United States Department of the Interior

IN REPLY REFER:
(ER 13/0532)

Subject: Draft Environmental Impact Statement (DEIS), National Aeronautics and Space Administration (NASA), Proposed Demolition and Environmental Cleanup Activities for the NASA administered portion of the Santa Susana Field Laboratory (SSFL), Ventura County, California.

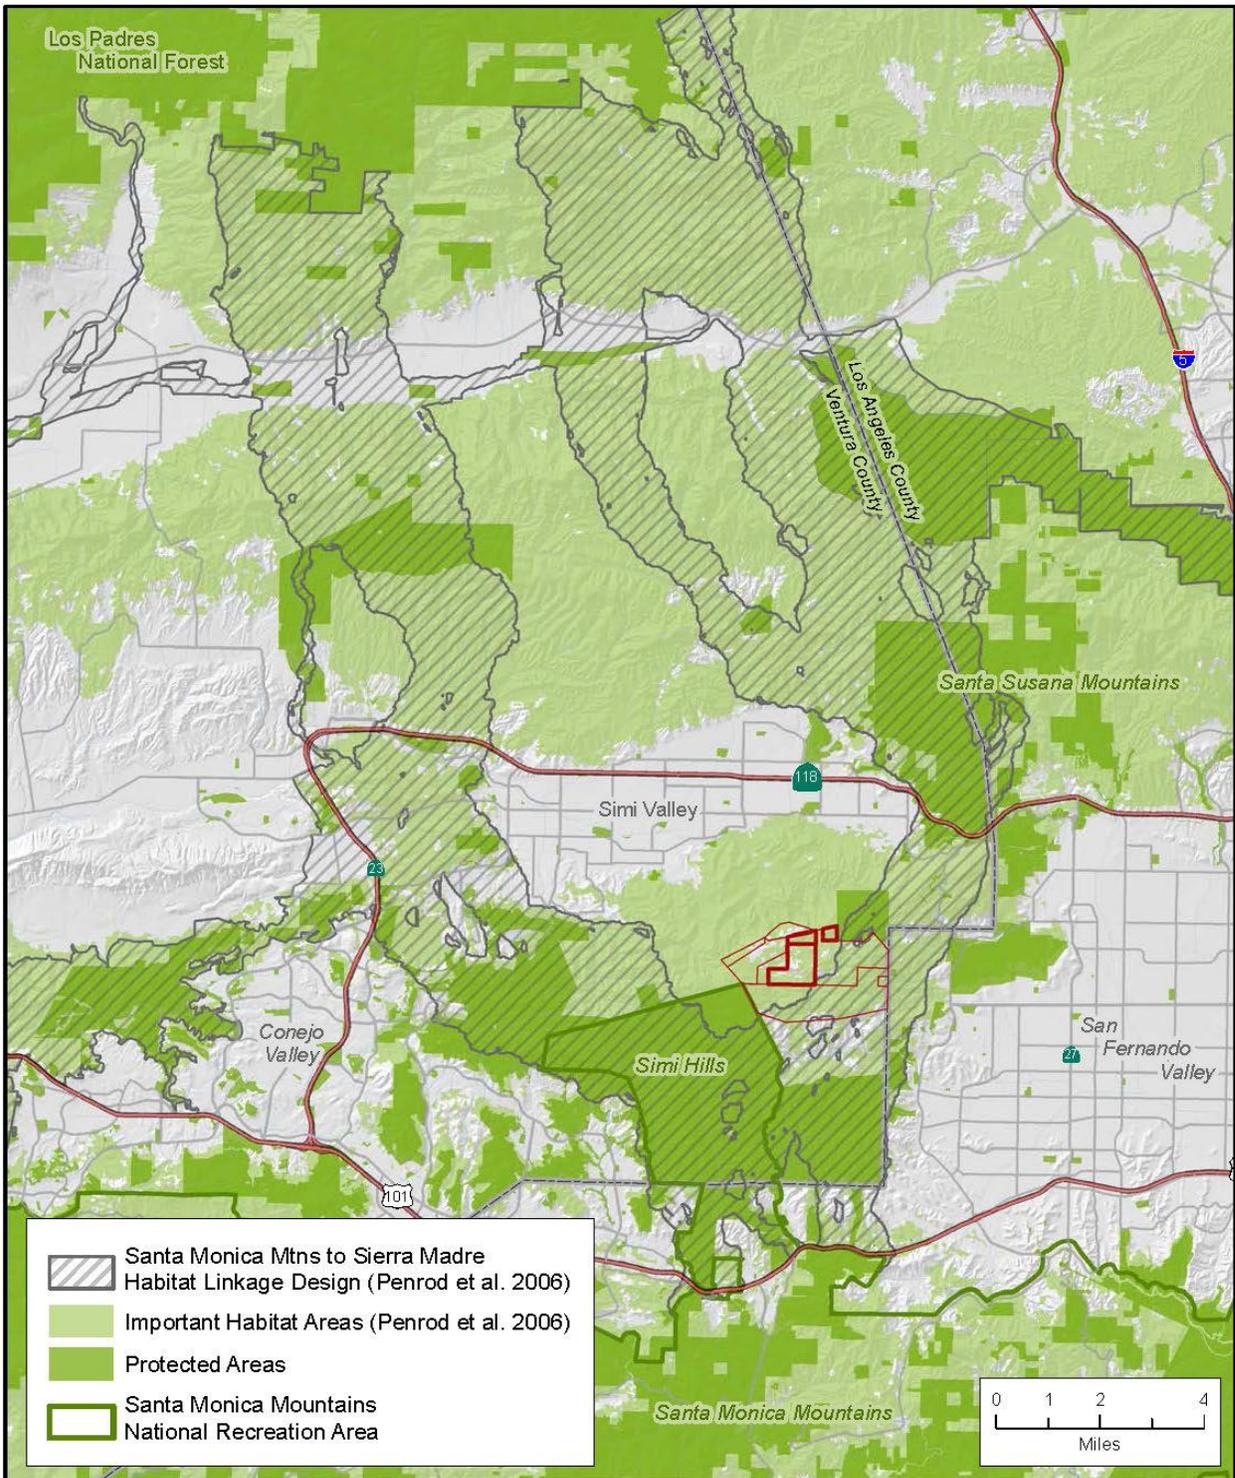
There is no regional vicinity map to illustrate the contextual setting of SSFL and the NASA portion among protected parkland, open space, and surrounding communities. The attached Figure 1 clearly illustrates the nexus of the proposed Project site and the surrounding regional parkland and open space setting. Maps in the Affected Environment and Appendices D and E either have no parkland identification or are missing several areas of public park land and protected open space. None of the maps includes the NPS-SMMNRA boundary. The SMMNRA boundary is shared with the southwestern boundary of SSFL. As noted previously, SSFL is ecologically continuous with the NPS-administered SMMNRA. The prehistoric archaeological sites are also connected to the greater prehistory and Native American cultural heritage of the Simi Hills and Santa Monica Mountains. It is critical to illustrate the parkland setting to more accurately disclose the project's potential for impacts to natural and cultural resources beyond the boundaries of SSFL and the NASA portion and to more fully disclose the site's current and potential future role in the region's ecology and recreation.

13.	Biological Resources Affected Environment Wildlife “Migration” Corridors Section 3.4.2	Figure 3.4-2 illustrates the habitat linkage area, but lacks habitat quality information and does not show park land and open space in the vicinity of the property. Thus, the figure does not adequately illustrate the location of this property in the context of existing parkland and important habitat. Please see attached NPS Figure 1 for a more accurate illustration of the greater park land and open space setting.
